ADDENDUM NO. 2

Colton MS Pavilion Building Addition

Colton Joint Unified School District 1212 Valencia Drive Colton, CA 92324

RCA Project No. 1-15-112

4A/AS-1.0 - OVERALL NEW SITE PLAN

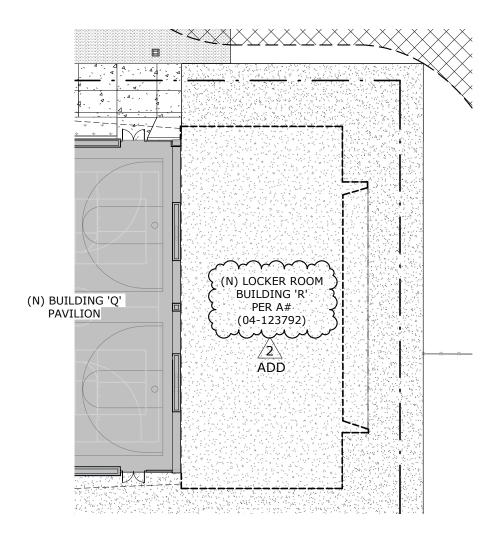
- Item No. 2.6 Reference sheet AS-1.0 OVERALL NEW SITE PLAN:
 - 2.6.1 Revise sheet AS-1.0 per clouded areas in attached sketch.
 - a. Revised detail 4A/AS-1.0 OVERALL NEW SITE PLAN per attached sketch ASK-2.01.
- Item No. 2.7 Reference sheet AS-2.0 -FIRE ACCESS SITE PLAN:
 - 2.7.1 Revise sheet AS-2.0 per clouded areas in attached sketch.
 - a. Revised detail 1/AS-2.0 OVERALL NEW SITE PLAN per attached sketch ASK-2.02.
- Item No. 2.8 Reference sheet AS-3.1 ENLARGED PORTABLE RESTROOMS:
 - 2.8.1 Remove sheet AS-3.1 in its entirety.

7/AD-3.1 - PARAPET CAP FLASHING

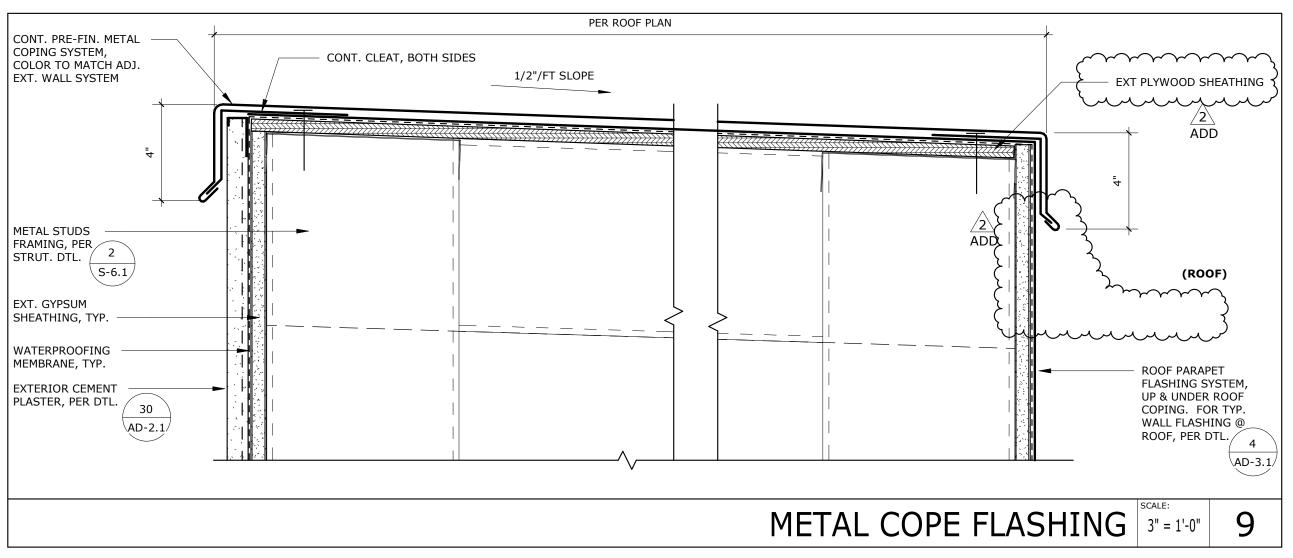
- Item No. 2.11 Reference sheet AD-3.1 -ROOF DETAILS:
 - 2.11.1 Revise sheet AD-3.1 per clouded areas in attached sketch.
 - a. Revised detail 7/AD-3.1 PARAPET CAP FLASHING per attached sketch ASK-2.03.

9/AD-7.1 - METAL COPE FLASHING

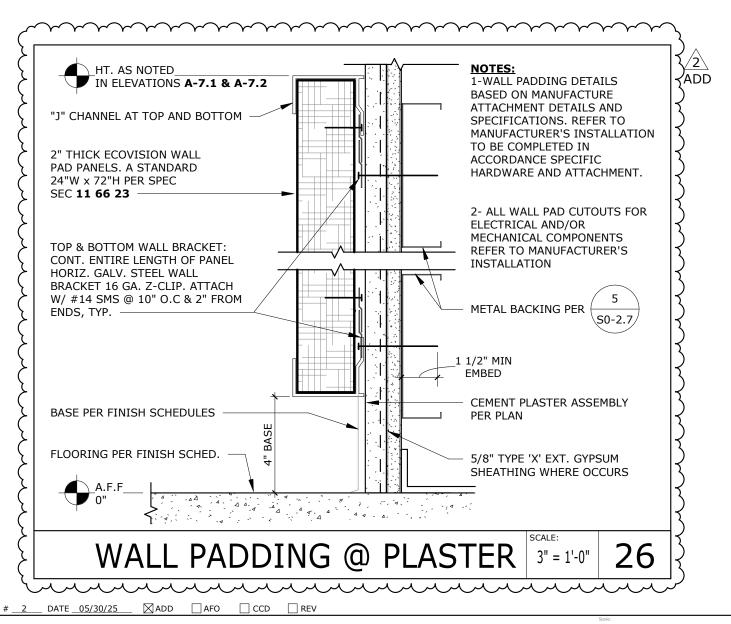
- Item No. 2.13 Reference sheet AD-7.1 MISCELLANEOUS DETAILS:
 - 2.13.1 Revise sheet AD-7.1 per clouded areas in attached sketches
 - a. Revised detail 9/AD-7.1 METAL COPE FLASHING per attached sketch ASK-2.04.

26/AD-7.1 - WALL PADDING @ PLASTER

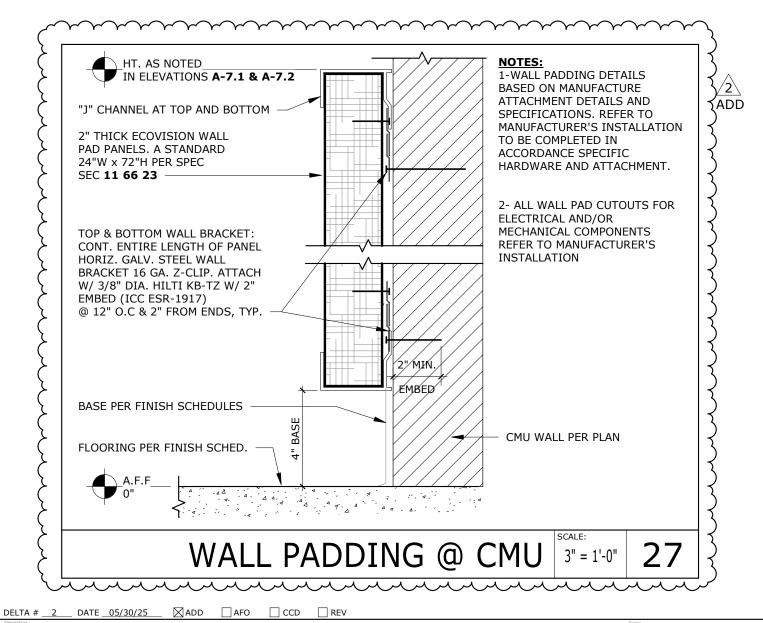
- b. Added detail 26/AD-7.1 WALL PADDING @ PLASTER per attached sketch ASK-2.05.
 - c. Added detail 27/AD-7.1 WALL PADDING @ CMU per attached sketch ASK-2.06.

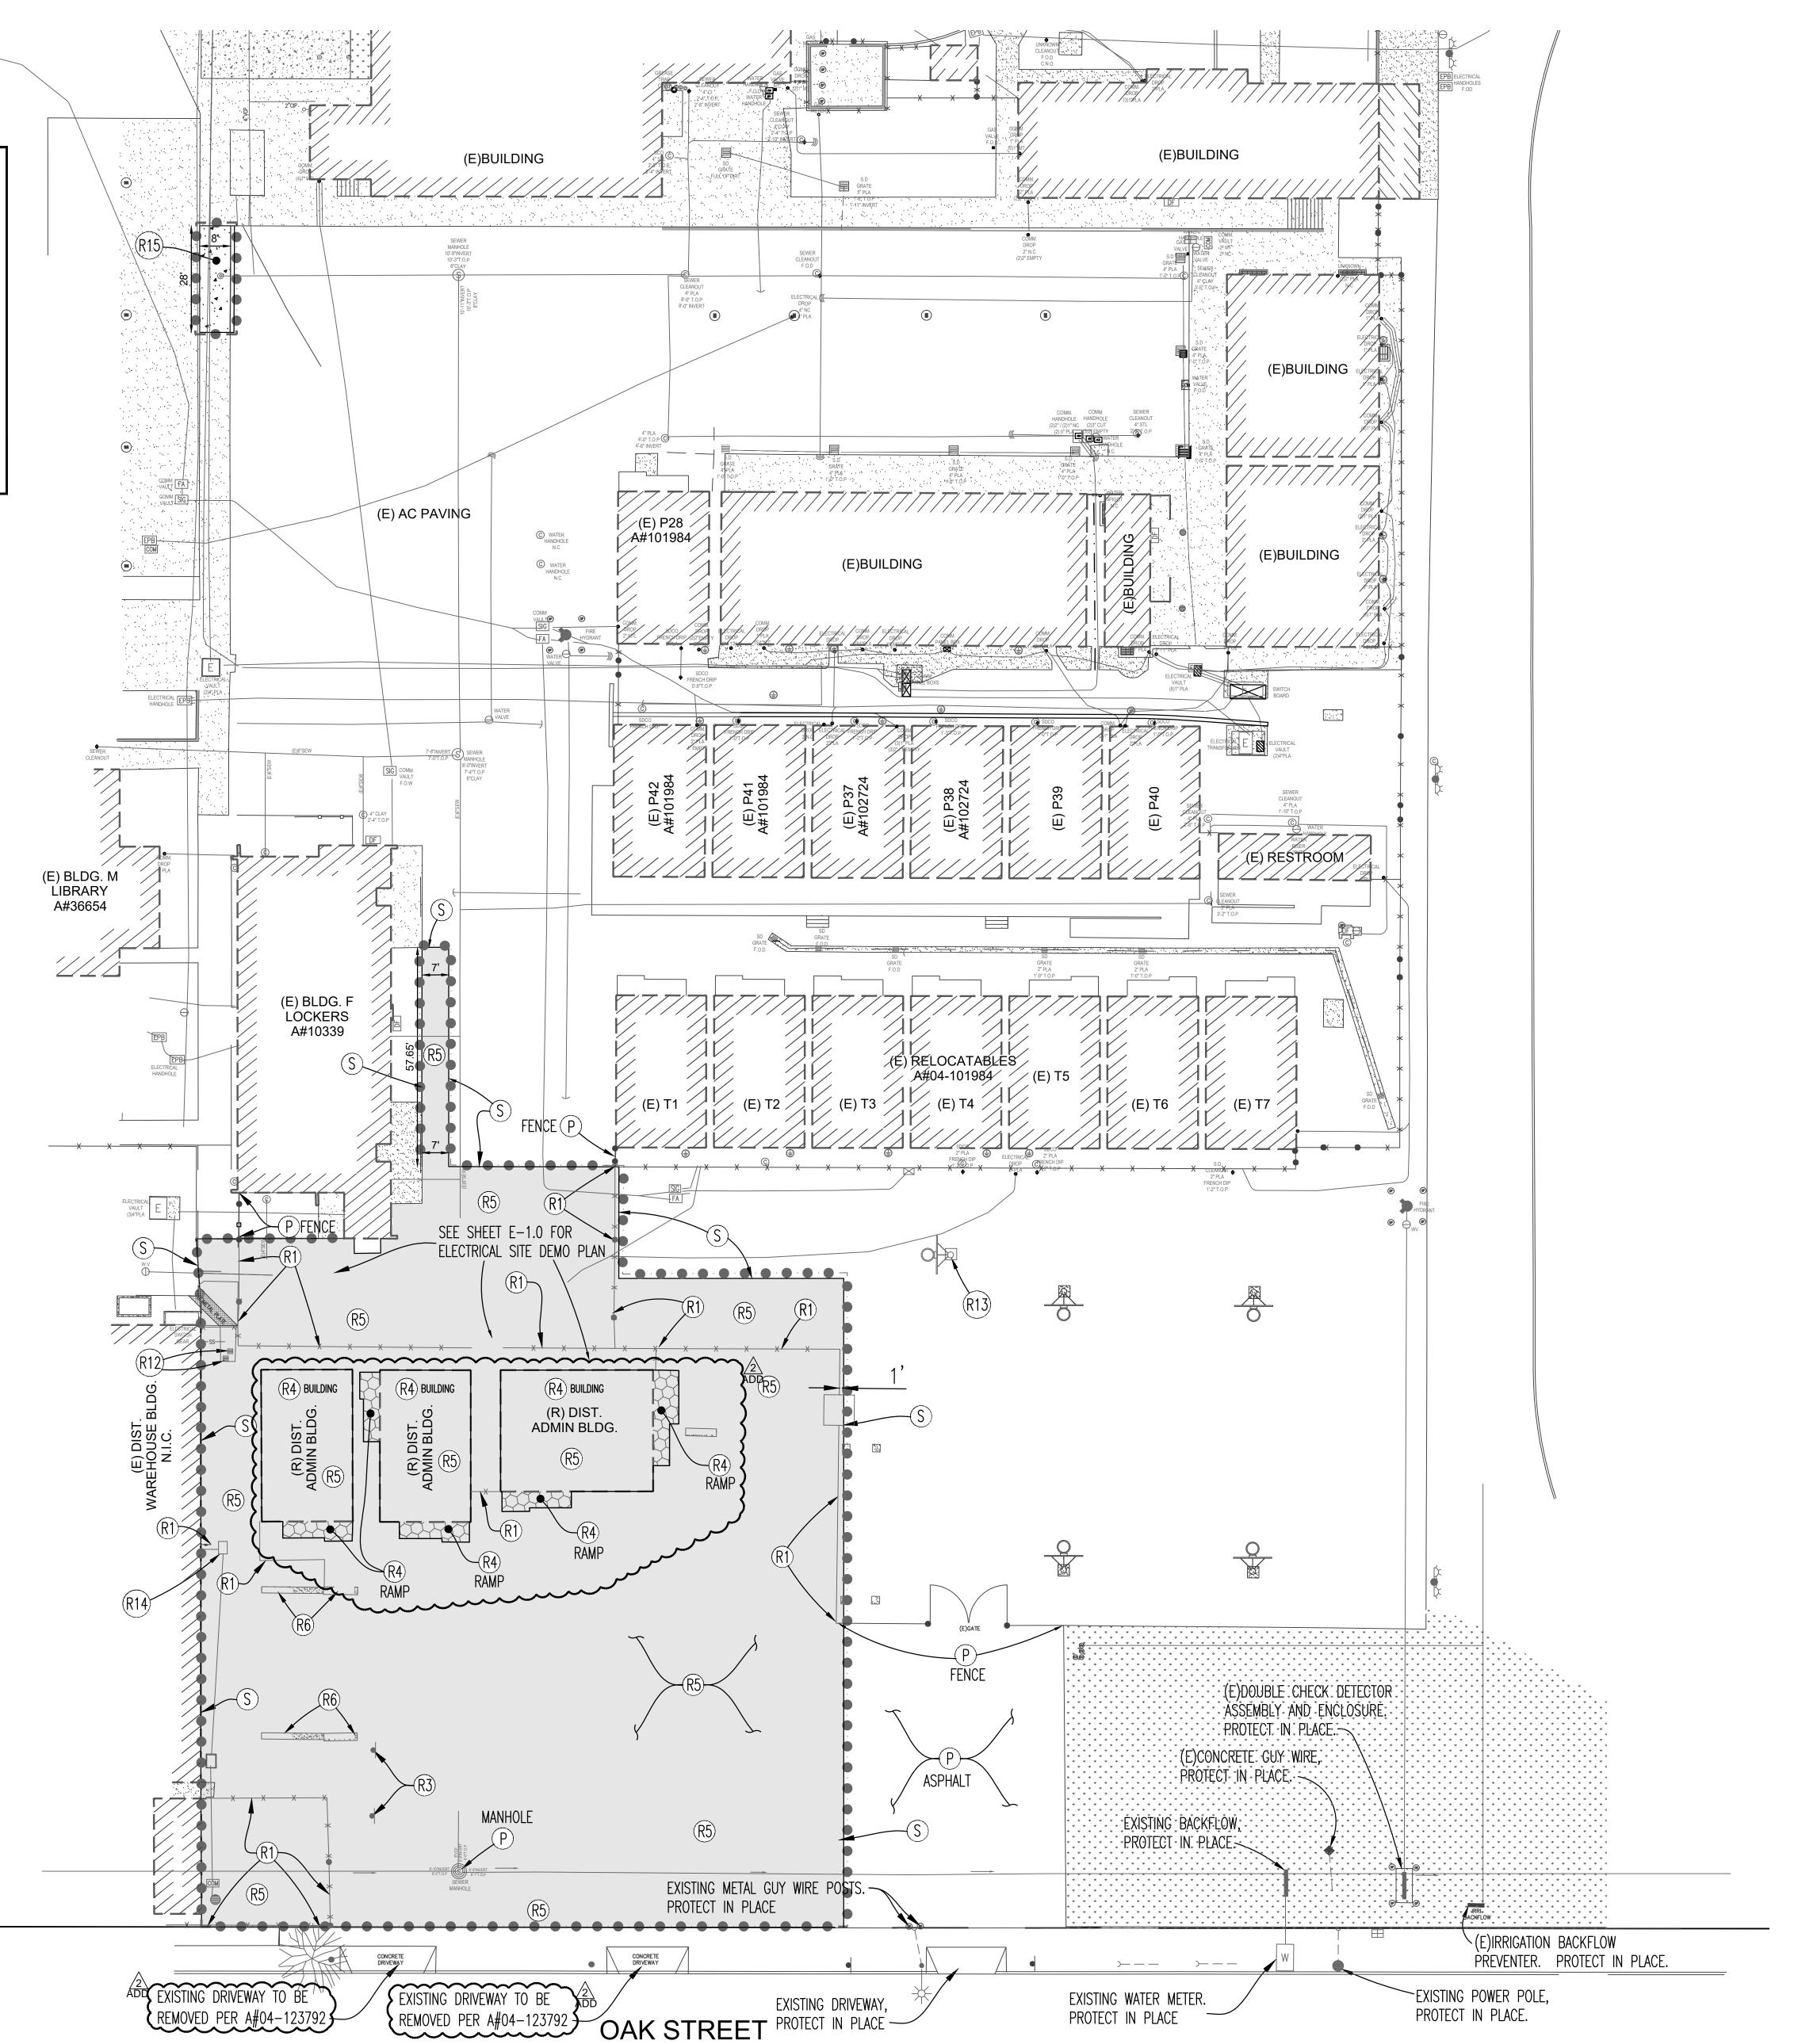
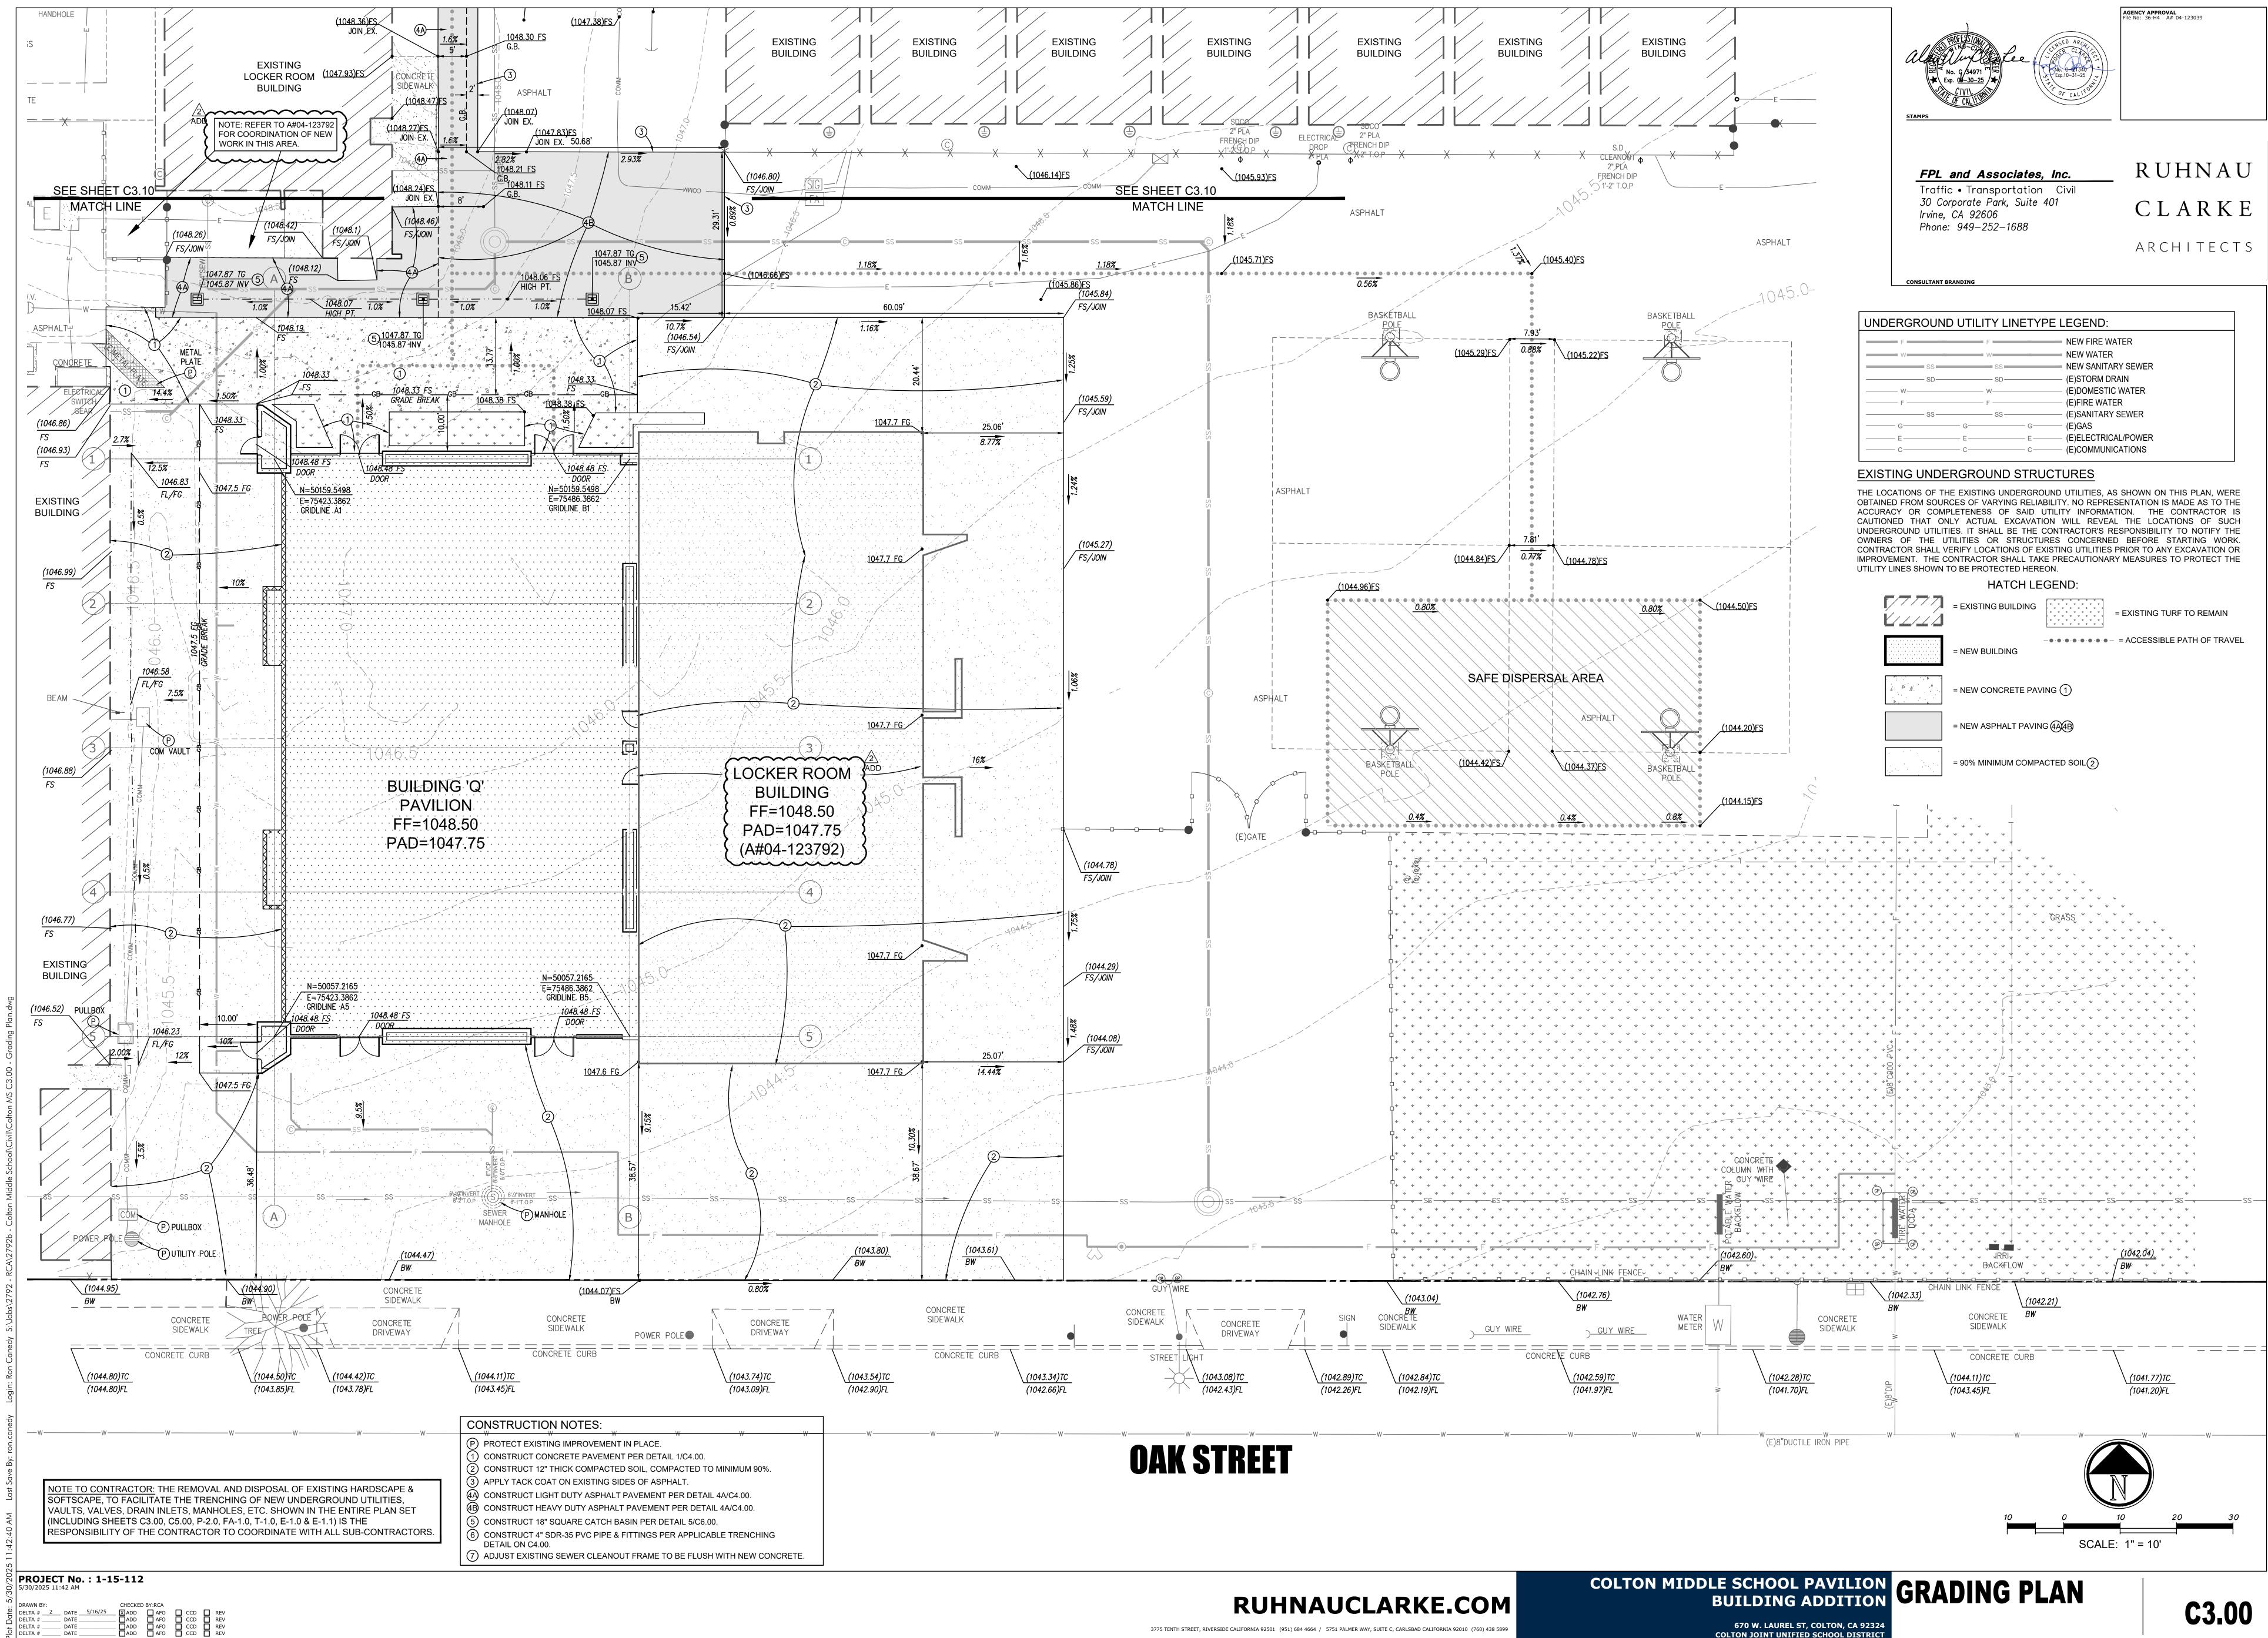
- Item No. 2.3 Reference sheet C2.00 DEMOLITION PLAN:
 - 2.3.1 Revise sheet C2.00 per clouded areas listed below.
 - a. Revised demolition note R4
 - b. Added note R4 to drawings at existing buildings
- Item No. 2.4 Reference sheet C3.00 GRADING PLAN:
 - 2.4.1 Revise sheet C3.00 per clouded area listed below.
 - a. Revised note locker room building
